REQUEST

Current Zoning: R-22MF (multi-family residential)
Proposed Zoning: UR-2(CD) (urban residential, conditional)

Approximately 0.917 acres located west of Baltimore Road, south of Remount Road, and east of Interstate 77.

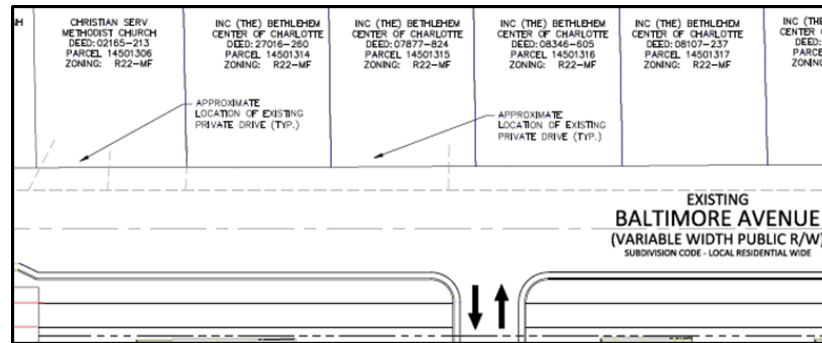
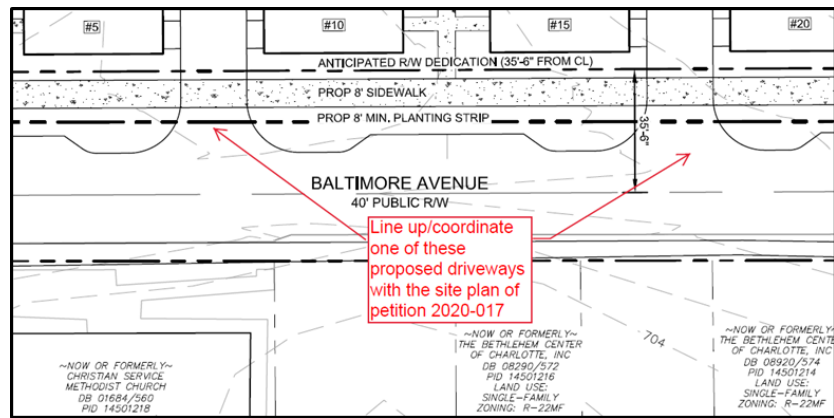
1. **Curbline** The proposed zoning district has a setback measured from back of the existing or proposed future curbline.
 - a. **Baltimore Avenue:** The proposed location of curb and gutter should be revised to 17.5 feet from existing road centerline, per the Urban Street Design Guidelines (USDG) Charlotte Land Development Standards Manual (CLDSM) standard detail U-03A – Local Residential Wide Street Typical Section and Chapter 19 of the Charlotte City Code. Curb and gutter should be constructed with on-street parking. The site plan should show the curb and gutter labeled and dimensioned from the centerline for each road.

2. Revise the site plan and conditional note(s) to construct a sidewalk connection to Remount Road with curb and gutter, in reference to the Vision Zero Action Plan and Charlotte WALKS. CDOT has notified Mecklenburg County of the possibility of the petitioner possibly attaining right of way and a construction easement to establish this connection. The proposed sidewalk connection will tie into the proposed improvements requested to rezoning petition 2019-017.
